8th & HOWELL

DESIGN RECOMMENDATION SUBMITTAL 2: 9.16.2014

DPD Project #: 3016917

DESCRIPTION OF REVISION - NORTH ELEVATION

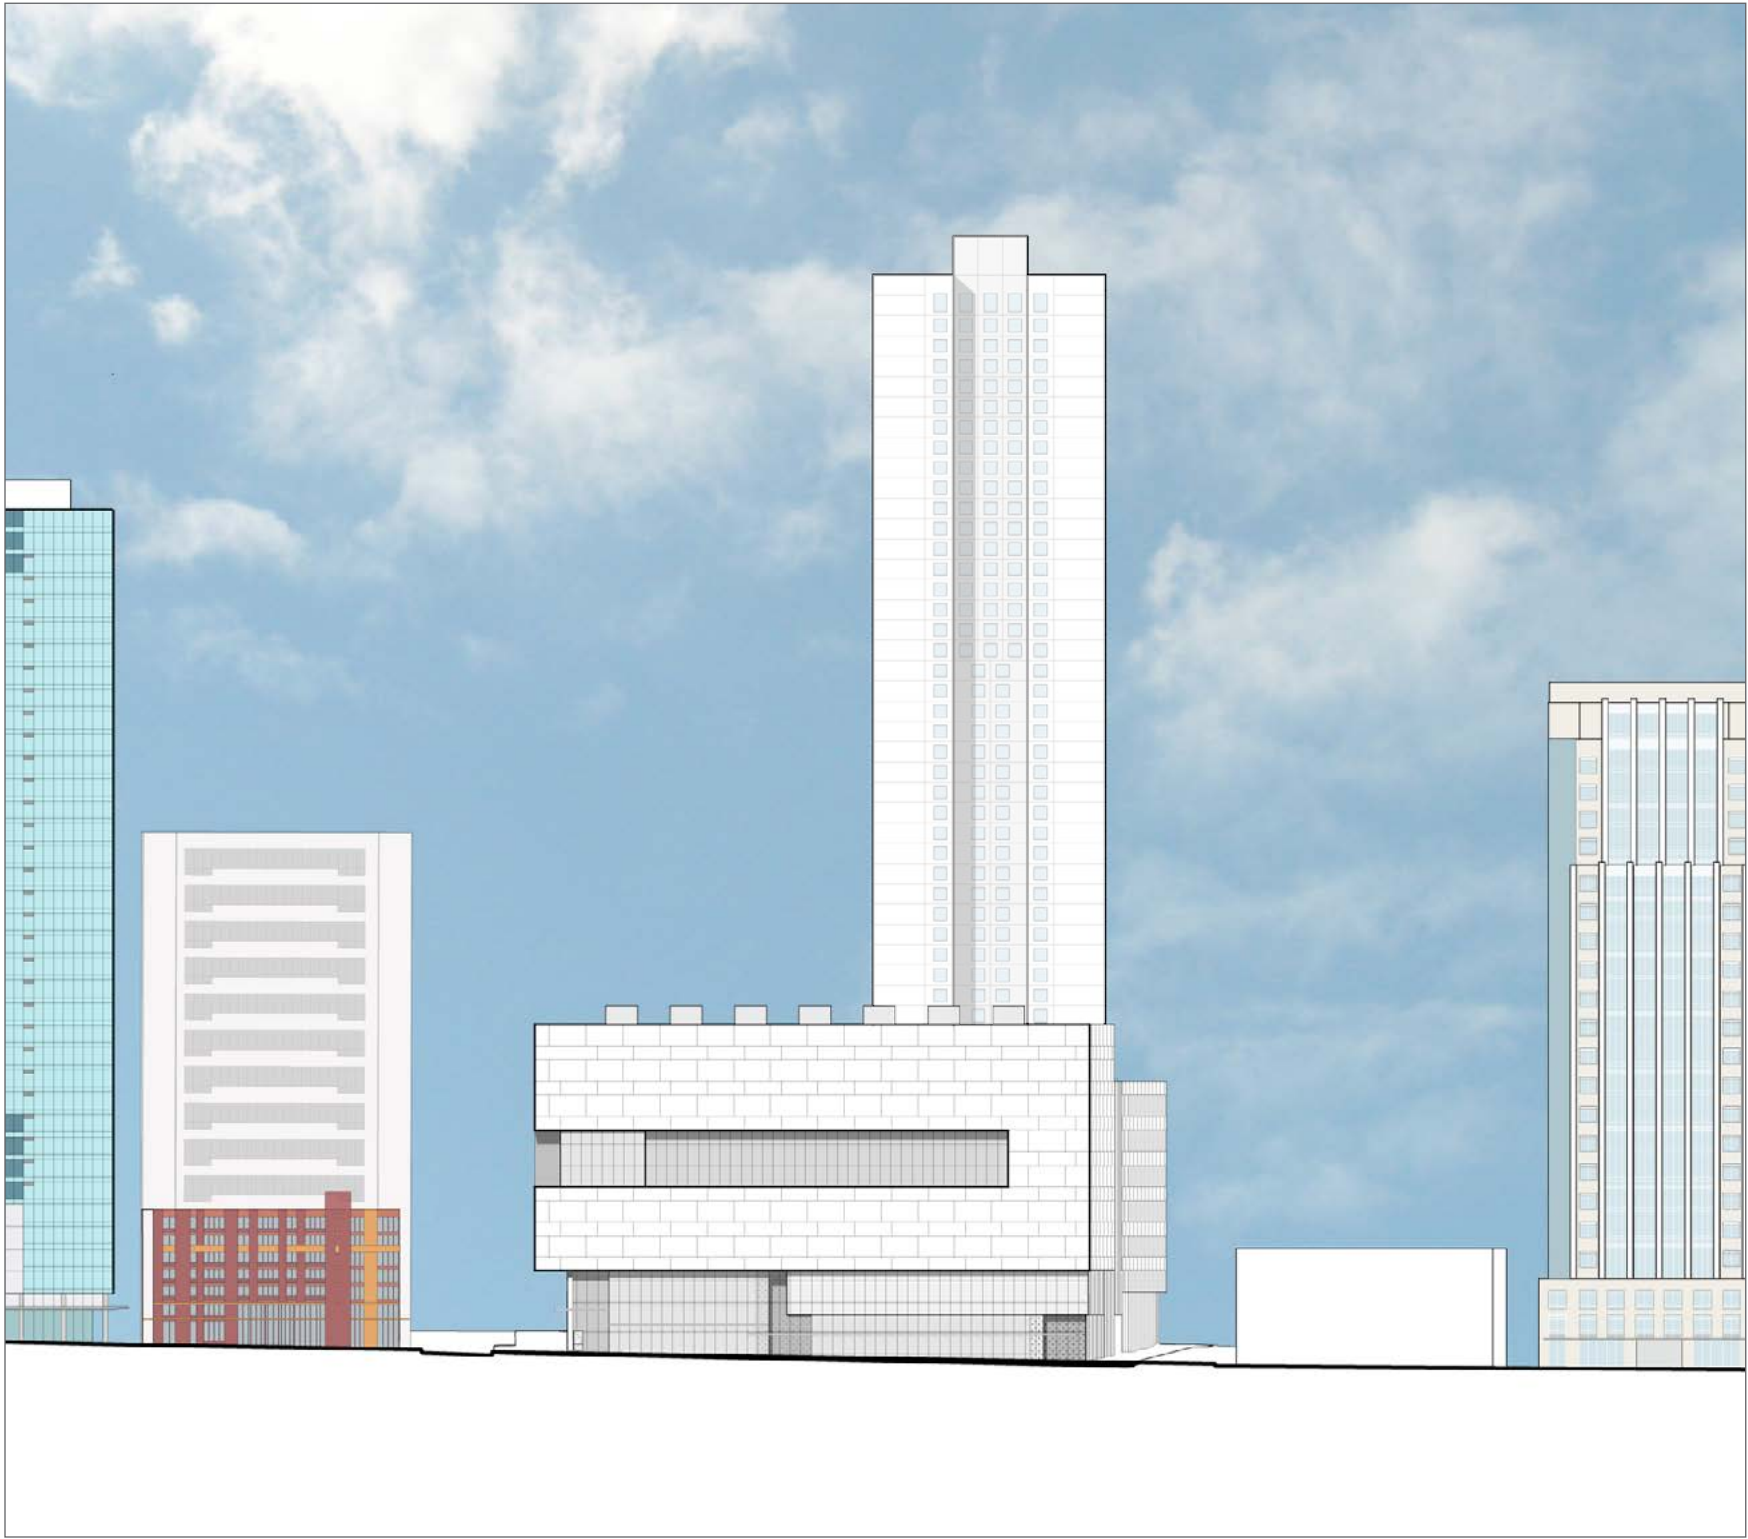
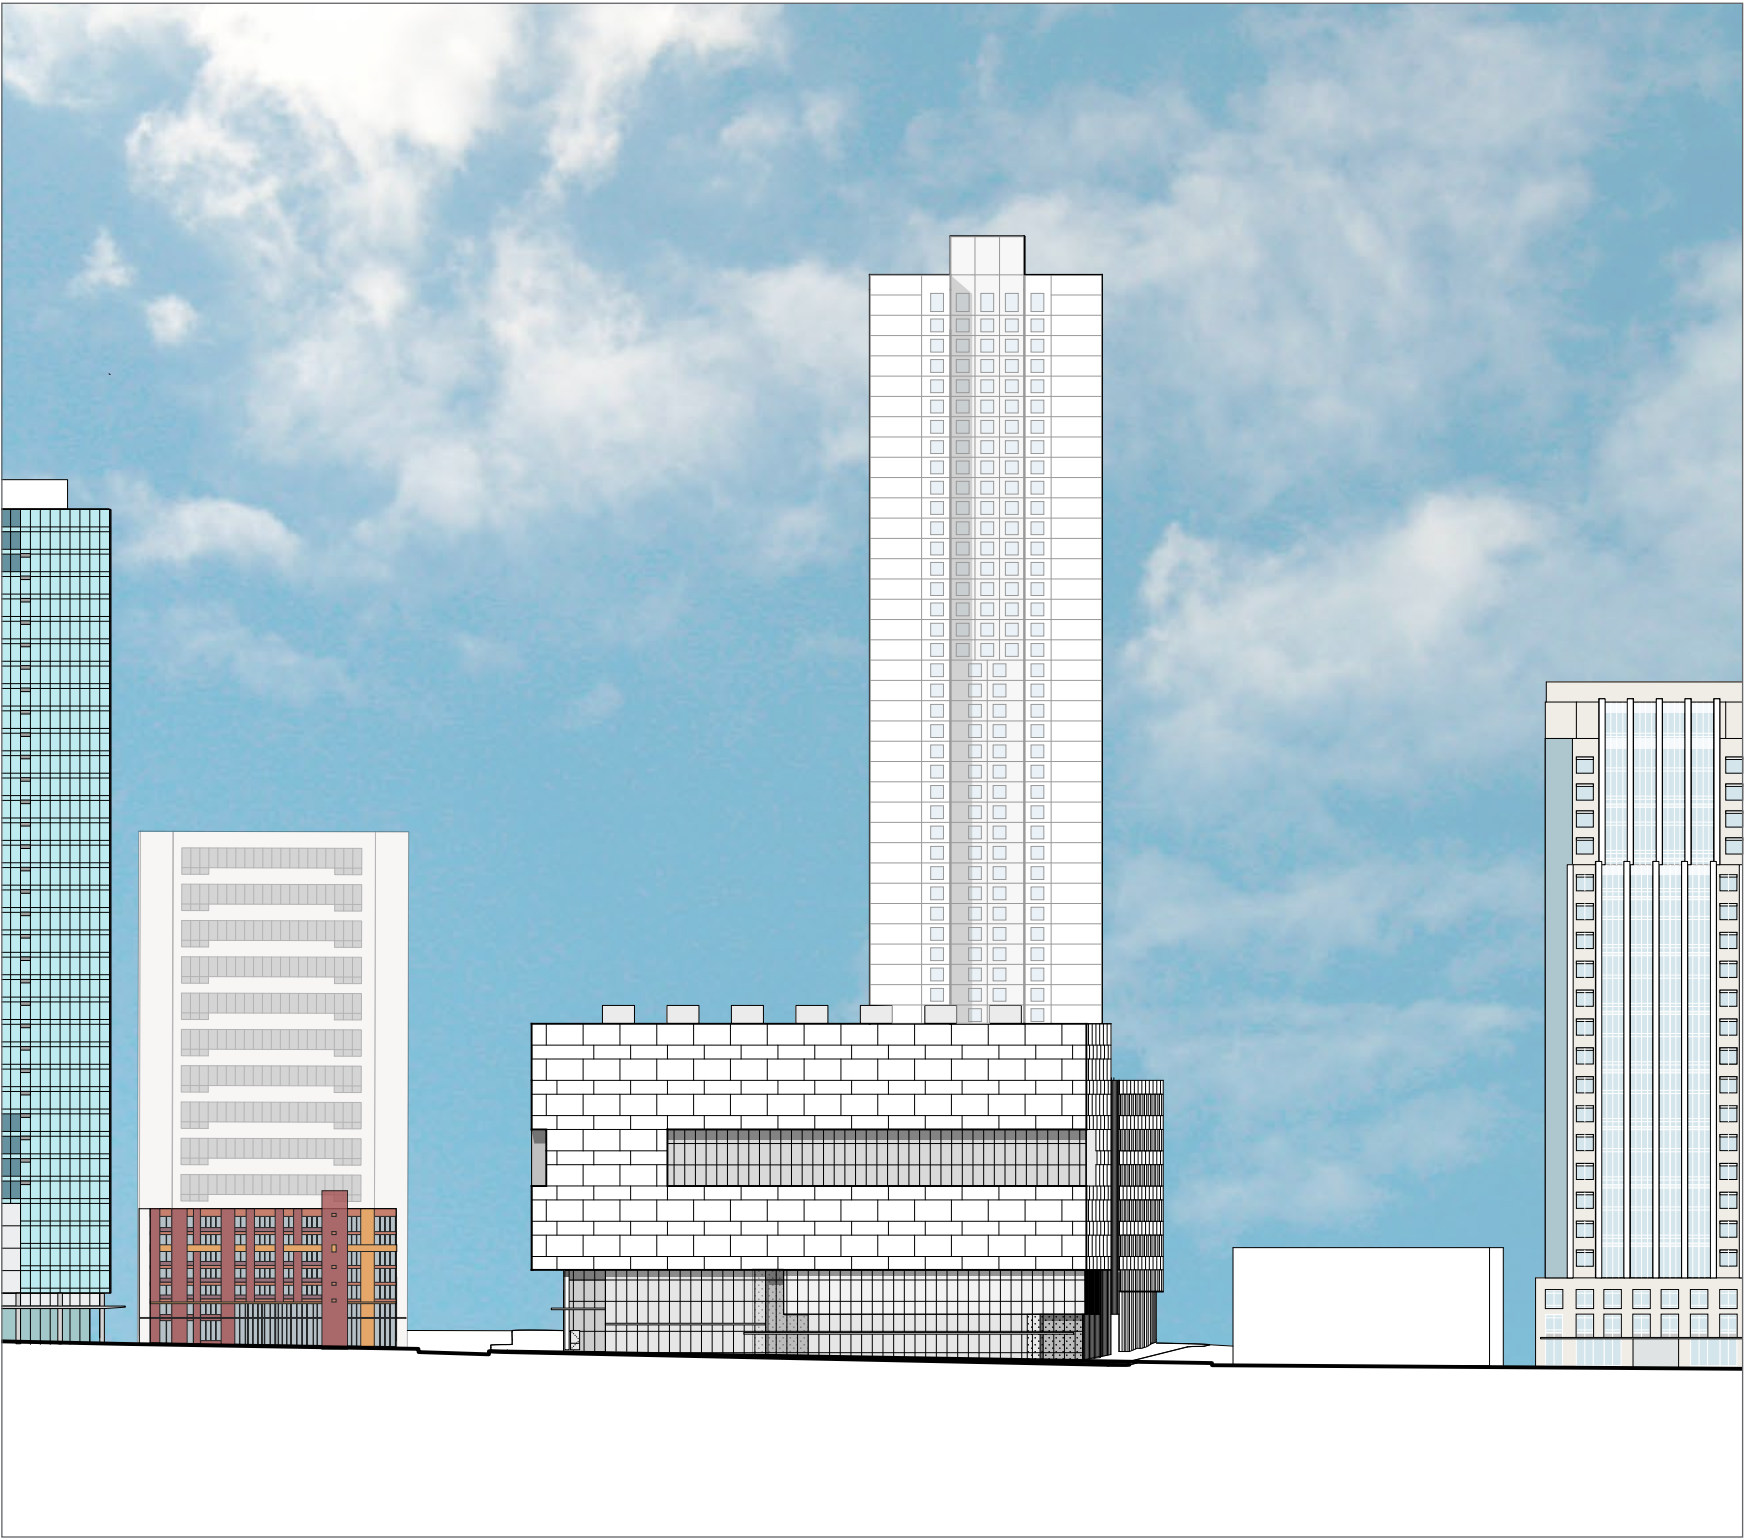
This submittal represents a design development of the glazed slot element that wraps the podium block along Stewart Street.

Following the first DRB meeting we have developed the program for the pre-function and meeting room space behind this glazed slot, and in seeking to maintain a clear expression of the cut, the precast façade now ends the slot at the corner of Stewart Street & 9th Avenue. To maintain modulation and visual intrigue at the corner of the green street, we have set back the edge of the precast to reinforce the window as a carved element within the building volume.

DESCRIPTION OF REVISION - WEST ELEVATION

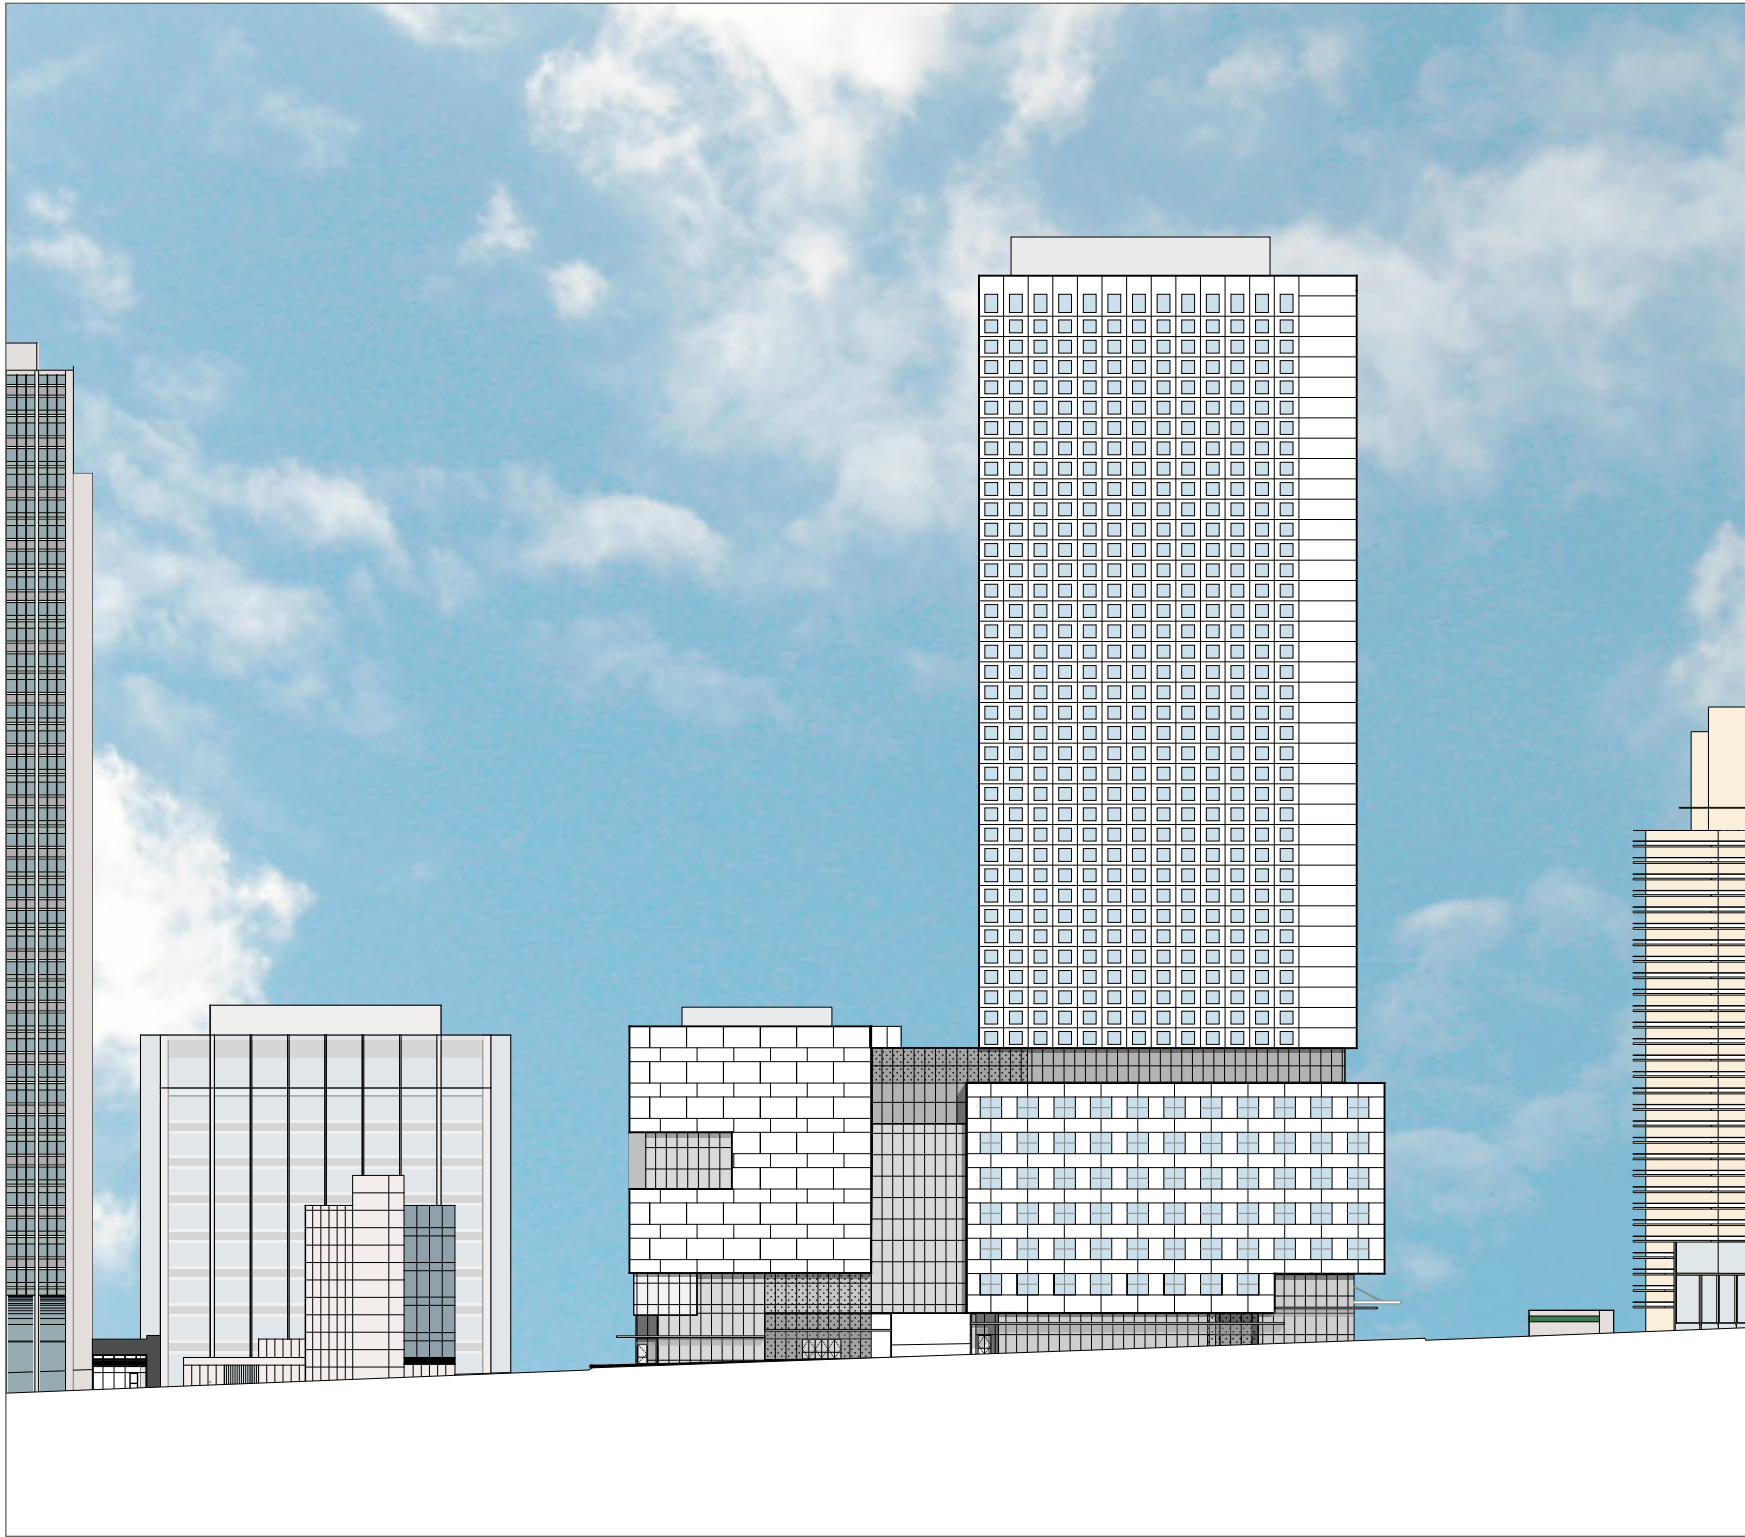
This submittal represents a design development of the glazed slot element that wraps the podium block along Stewart Street.

In line with the programmatic development of the interior, and updated expression at the North façade, the glazed slot now wraps the corner at Stewart Street & 8th Avenue, providing daylighting and views from the pre-function space, and additional visual modulation on the façade of 8th Avenue.

Stewart Street Façade Setback

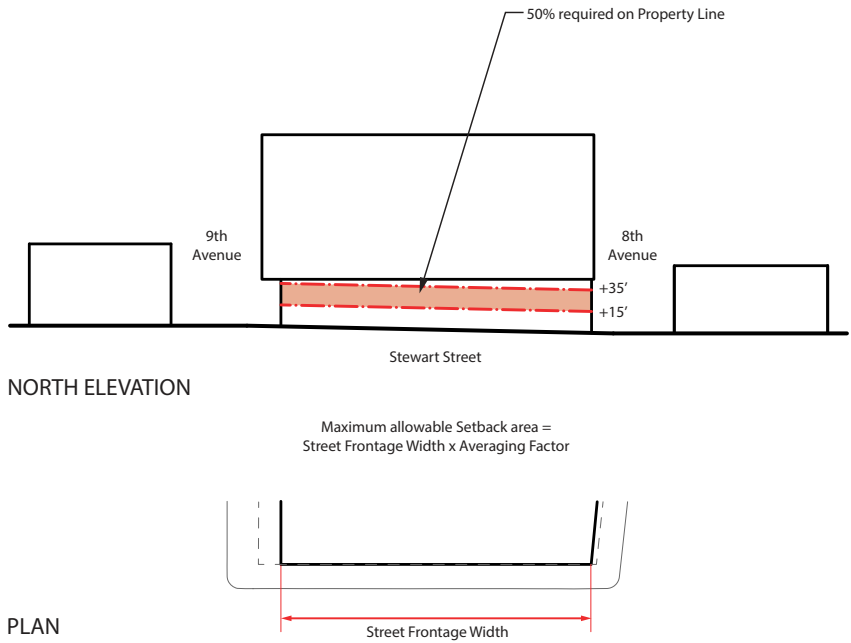
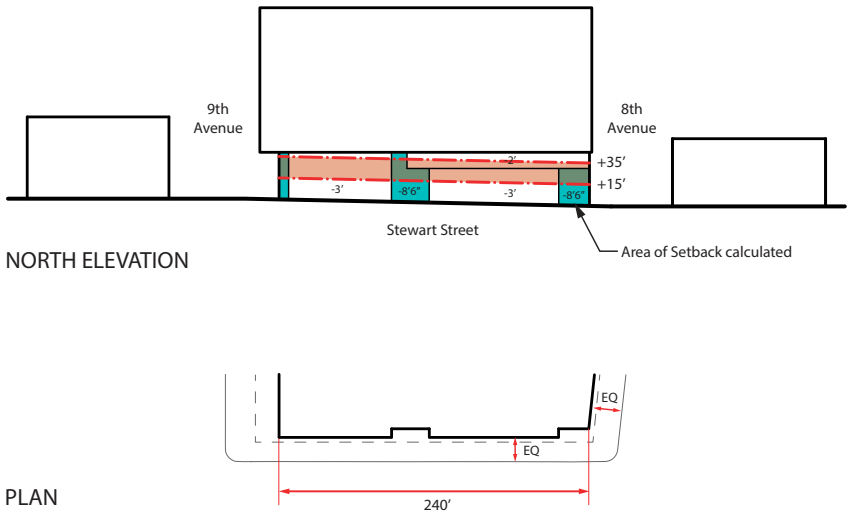
ITEM #	DEVELOPMENT STANDARD	REQUIREMENT	RATIONALE	DOWNTOWN DESIGN GUIDELINES REINFORCED
5	23.49.056.B Facade Setback Limits	<p>The maximum area of all setbacks between the street lot line and facade along each street frontage of a lot shall not exceed the area derived by multiplying the averaging factor by the width of the street frontage of the structure along that street (see Exhibit D for 23.49.056). The averaging factor is five on Class I pedestrian streets and ten on Class II pedestrian streets and designated green streets.</p> <p>If a sidewalk is widened into the lot as a condition to development, setback standards shall be measured to the line established by the new sidewalk width rather than the street property line.</p>	<p>The proposed scheme seeks to create a consistent expression at the street level, with glass façades stepped back from the building edge above. At Stewart Street, the existing setback varies from the requirements on 8th & 9th Avenues, and to create a unified street level expression, we are proposing to voluntarily widen the sidewalk at Stewart by 3'. This wider sidewalk also helps to avoid conflicts with existing street canopy and the required weather protection elements on the street. The widening of the sidewalk on Stewart Street also creates equity to the other sidewalks around the property.</p>	<p>A-1 Respond to the physical environment</p> <p>B-1 Respond to the neighborhood context</p> <p>B-2 Create a transition in bulk and scale</p> <p>B-3 Reinforce the positive urban form & architectural attributes of the immediate area</p> <p>B-4 Design a well-proportioned and unified building</p> <p>C-1 Promote pedestrian interaction</p> <p>C-2 Design Facades of many scales</p> <p>C-4 Reinforce building entries</p> <p>D-2 Enhance the building with landscaping</p>
